DESIGN <i>[Signature]</i>	DRAWN BY <i>[Signature]</i>	DART AEROSPACE LTD HAWKESBURY, ONTARIO, CANADA	
CHECKED <i>[Signature]</i>	APPROVED <i>[Signature]</i>	DRAWING NO. D2580	REV. D SHEET 1 OF 3
DATE 07.02.27		TITLE 205 SKIDTUBE ASSEMBLY	SCALE NTS
A	96.09.16	NEW ISSUE	
B	96.12.02	AS MANUFACTURED	
C	98.08.26	REDRAWN, INCLUDED DEO 9094/9097	
D	07.02.27	CHANGE TO SS WEARPLATES AND GASKETS, INCLUDE DEO 9124/9183

DRAWING NO. D2580	TITLE 205 SKIDTUBE ASSEMBLY	REV. D	DART AEROSPACE LTD ENGINEERING ORDER		D.E.O. NO. D2580-D-1	SHEET NO. SHEET 1 OF 1	SCALE NTS
DRAWN <i>UP</i>	CHECKED <i>L</i>	MFG. APPR. <i>R</i>	APPROVED <i>MP</i>		DE APPR. <i>MP</i>		
DATE 10.09.22	DATE 10.11.04	DATE 10.11.04	DATE 10/11/04		DATE 10.11.04

PURPOSE:

CHANGE ALL WELDED CROSSBOLT SPACERS TO SWAGED SPACERS

SECTION D-D & SECTION H-H ARE AMENDED AS FOLLOWS:

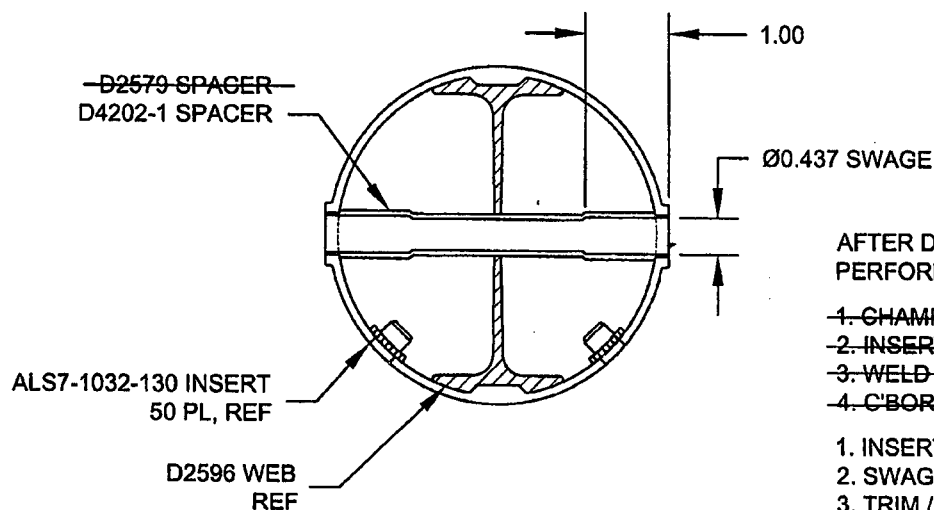
AFTER DRILLING AND BENDING ASSEMBLY
PERFORM THE FOLLOWING FOR Ø0.508 HOLES ONLY:

1. CHAMFER HOLE 0.050 X 45°
2. INSERT D2579 SPACER (20 PLACES)
3. WELD INTO PLACE AND GRIND FLUSH
4. C'BORE D2579 SPACER TO Ø0.437 X 1.00 DEEP

1. INSERT D4202-1 SPACER, 20 PL (-041) OR 24 PL (-045)
2. SWAGE TO Ø0.437 X 1.00 DEEP PER QSI 002
3. TRIM / GRIND FLUSH PER QSI 002
